19 December 2022

Attention: Mr Gary Hinder
Re: Submission to PP-2022-3978
Gilead Stage 2 Planning Proposal

Figure 1.1 Gilead 2 Proposal (left) and Greater Macarthur 2040 (right) Extracts

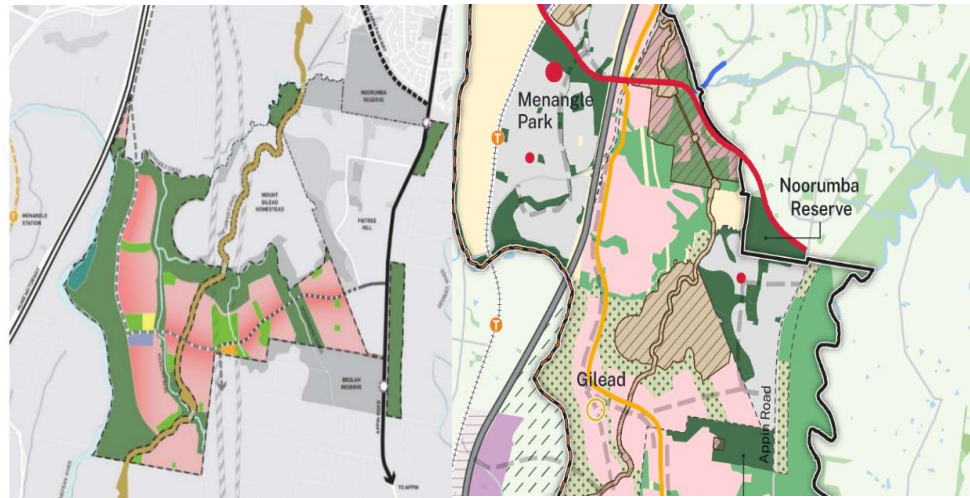
The alignment of the proposed corridor depicted in the Gilead 2 Structure Plan (on the western perimeter) is questioned in terms of its public transport attraction and functionality, including the relationship to the proposed village centre and ultimate southbound “T” intersection. The principle of integrated land use and transport in this context needs major review.

The proposed Gilead 2 road alignments including the transit corridor, do not match the recent Greater Macarthur 2040 alignment as shown in the diagrams below:

Figure 1.3 – Potential general location of active open space, shown in BLUE. Proposed active open space in Menangle Park and Rosalind Park shown in the RED circles.

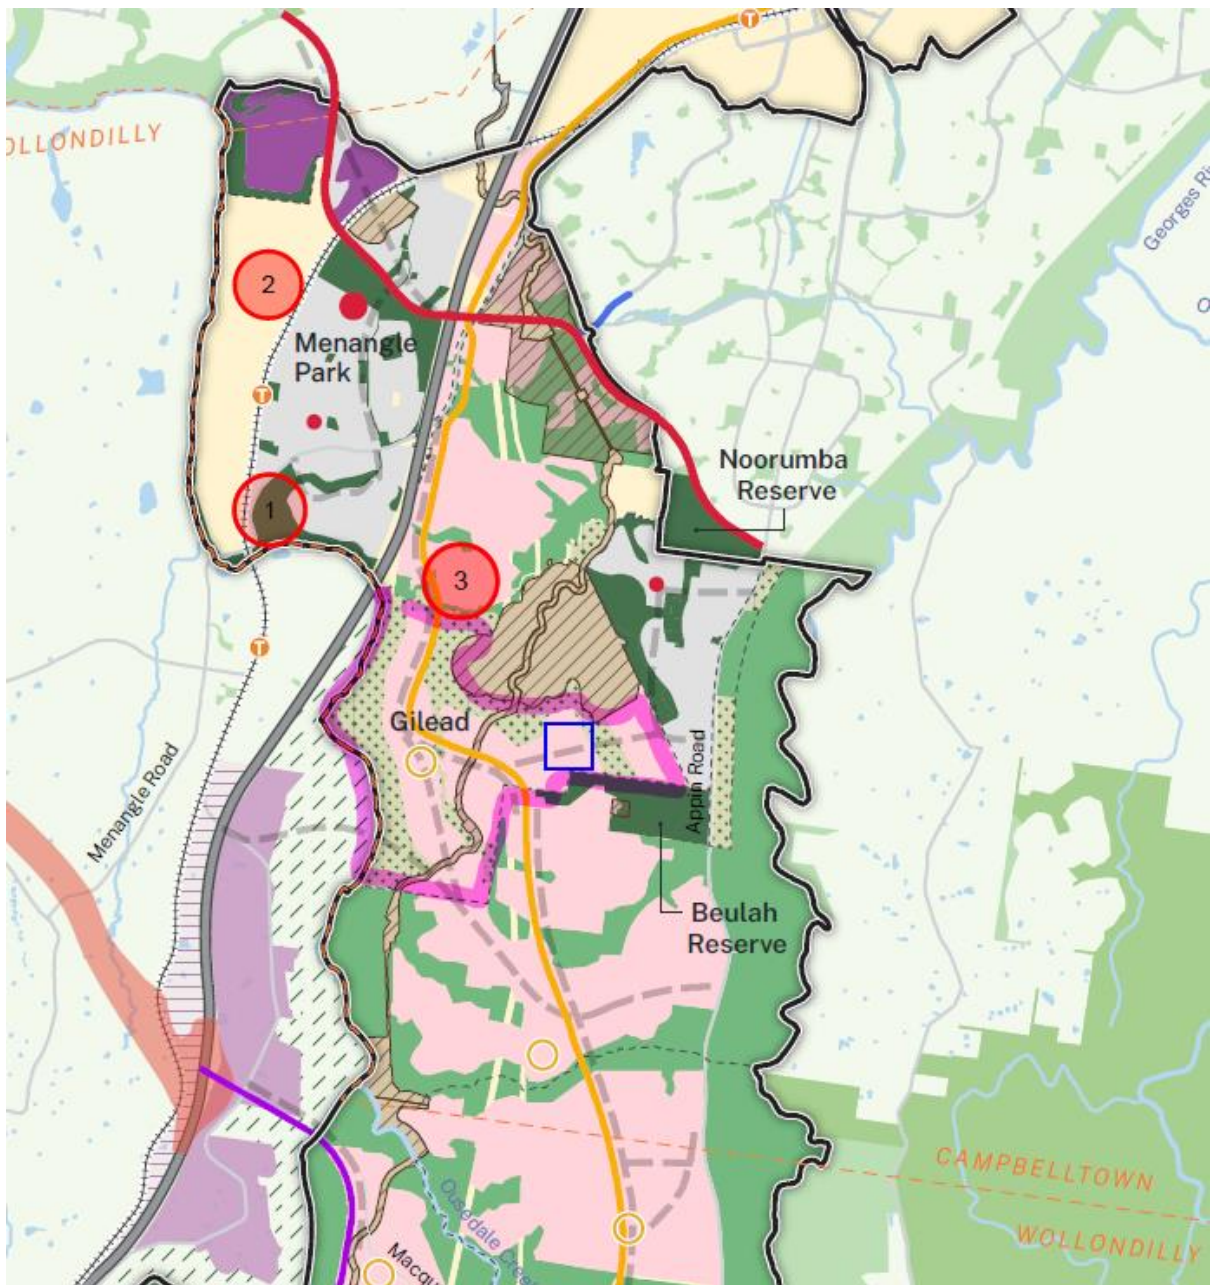
Council's preference is for a single active open space parcel of 20.9 hectares in size, rectangular in shape if possible to allow maximum flexibility for use. By way of example, Figure 1.2 provides a general arrangement layout that could be delivered on a 20ha site. The example is from Mount Barker, South Australia. Please note this is an example for illustrative purposes only. Council has yet to determine the full range of active uses required by the future community. It could incorporate aquatic facilities, indoor and outdoor recreational facilities, dog parks, skate parks, BMX tracks, fitness park and community facilities. An indicative location, central to Gilead Stage 1 & 2 is shown below in Figure 1.3 to meet the active open space needs of the proposed development. The BLUE square is to reasonable scale, being of approximately 455m x 455m in size (20.7ha).

In this regard, Figure 1.3 also details the proposed active open spaces to be provided within Menangle Park (CIRCLES 1 & 2) and those proposed for Rosalind Park (CIRCLE 3). While Council will always engage with all stakeholders in developing the optimum shape and location of the active open space parcel, the location shown is considered central to Gilead Stages 1 & 2 and not in immediate proximity to the proposed open space in Rosalind Park. Ideally these active open spaces are located to serve walkable catchments (400-800m) and should therefore be located 800-1,600m apart.

Council notes that one such likely piece of state/regional infrastructure is the Indicative Transport Corridor (seen in Figure 1.3). This includes a substantial and significant bridge crossing of Menangle Creek, connecting to Medhurst Road to the north and subsequently connecting to Menangle Road. The delivery of the "Transport Corridor" from Menangle Road and across Menangle Creek needs to be coordinated by Transport for NSW and the design, timing and delivery should service the interests of both proponents across which land the transport corridor traverses.
